Subject: Response to County of Santa Clara Department of Planning Review Comments from Rebecca Rockom for Joe Tran, letter dated February 3, 2023.

Address: 11555 Kannely Lane, Gilroy, CA
APN: 830-05-051
County File No. PLN23-002

Sheet no.: 1 of 2

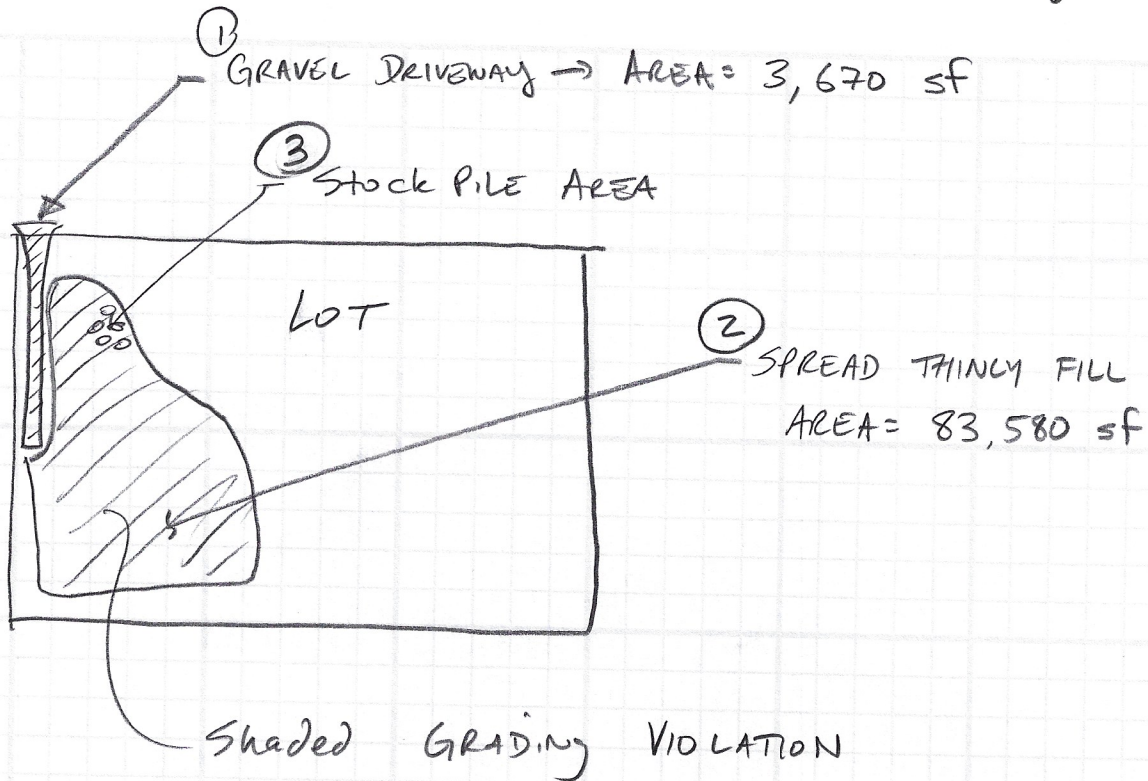
EARTHWORK CALC'S FOR AREAS ①, ②, ③
ON NEXT PAGE. VERIFY THAT
AUTOCAD CALCULATIONS SHOWN ON
PLANS ARE ACCURATE WITHIN
MARGIN OF AREA ACCEPTABLE FOR
PROJECT LIKE THIS.
